# Access Compliance Report

## Public Rights-of-Way

Intersection ID: 10037212	Main Street: SANDY_ROCK_PL	Cross Street: N/A	Location: NW
ADA ID: B349F70098DE	Ramp Type: Perp	Initial Pass/Fail: Fail	Overall Compliance: No
		Severity Score: 12.5	
Codes/Mitigation Info/Possible Solution		Field Measurements/Component Compliance

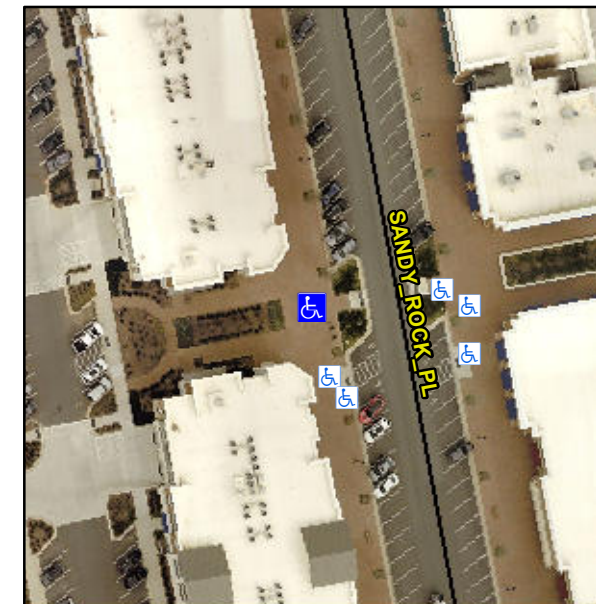
**Not Found, R304.2.2**

Compliance	Description	Data	Compliance	Description	Data
N/A	Ramp Length (in)	83.0	No	Ramp Slope (%)	8.7
Yes	Ramp Width (in)	95.0	Yes	Ramp XSlope (%)	1.9
N/A	Flare Type LT	N/A	N/A	Flare Type RT	N/A
N/A	Flare Slope LT (%)	N/A	N/A	Flare Slope RT (%)	N/A
N/A	Flare Traversable LT?	N/A	N/A	Flare Traversable RT?	N/A
N/A	Landing Length (in)	N/A	N/A	DWS Provided?	N/A
N/A	Landing Width (in)	N/A	N/A	DWS Contrast?	N/A
N/A	Landing Slope (%)	N/A	N/A	DWS Length (in)	N/A
N/A	Landing X Slope (%)	N/A	N/A	DWS Full Width?	N/A
N/A	Landing Curb? (Y/N)	N/A	N/A	DWS Offset (in)	N/A
N/A	Shared Landing?	N/A			
N/A	Gutter Ponding?	N/A	N/A	Gutter Slope (%)	N/A
N/A	Gutter Lip Ht (in)	N/A	N/A	Gutter X Slope (%)	N/A
N/A	Painted X Walk1?	No	N/A	Painted X Walk2?	N/A
	X Walk 1 Direction	To E		X Walk 2 Direction	N/A
N/A	X Walk 1 Width (in)	N/A	N/A	X Walk 2 Width (in)	N/A
	X Walk 1 Slope (%)	1.5		X Walk 2 Slope (%)	N/A
	X Walk 1 X Slope (%)	2.0		X Walk 2 X Slope (%)	N/A

**Remove & Replace Entire Ramp.**
